Access Compliance Report Public Rights-of-Way (Curb Ramps)

Main Street: N_GLENROSE_DR Cross Street: E_SPRING_ST Location: NE

ADA ID: RPAT210927112213 Ramp Type: Type 1 - Perpendicular Diagonal Initial Pass/Fail: Fail Overall Compliance: No Severity Score: 15

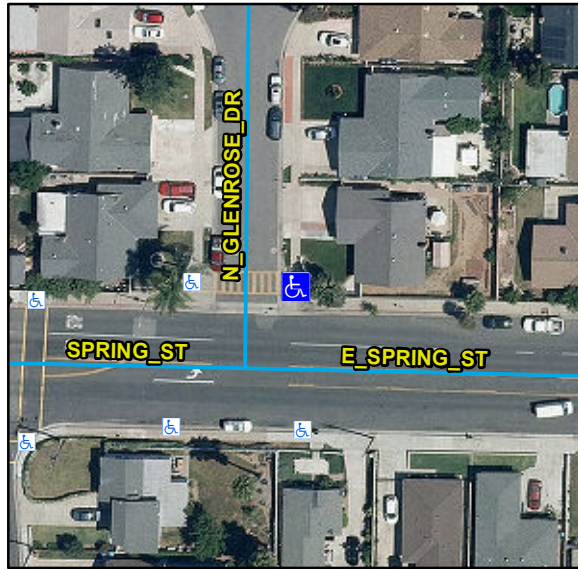
Compliance	Description	Data	Compliance	Description	Data
N/A	Ramp Length (in)	79	N/A	Flare Type LT	
Yes	Ramp Width (in)	48			N/A
No	Ramp Run Slope (%)	10.1	N/A	Flare Slope LT (%)	N/A
Yes	Ramp Cross Slope (%)	1.1	N/A	Flare Traversable LT	N/A
N/A	Landing Present	N/A	N/A	Flare Type RT	
N/A	Landing Length (in)	N/A			N/A
N/A	Landing Width (in)	N/A	N/A	Flare Slope RT (%)	N/A
N/A	Landing Run Slope (%)	N/A	N/A	Flare Traversable RT	N/A
N/A	Landing Cross Slope (%)	N/A	N/A	DWS Provided	N/A
N/A	Landing Movement Obstructed?	N/A	N/A	DWS Contrast	N/A
	Landing Movement Type	N/A	N/A	DWS Length (in)	N/A
N/A	Landing Shared	N/A	N/A	DWS Full Width	N/A
N/A	Clear Space	Yes	N/A	DWS Offset Left (in)	N/A
N/A	Clear Space To Crosswalk (in)	N/A	N/A	DWS Offset Right (in)	N/A
N/A	Marked Crosswalk 1	Yes	N/A	Marked Crosswalk 2	No
	Crossing 1 Direction	W		Crossing 2 Direction	S
	Marked Crosswalk 1 Width (in)	120		Marked Crosswalk 2 Width (in)	N/A

Remove & Replace Curb Ramp With Two New Directional Ramps or Equivalent. Restripe Crosswalk.
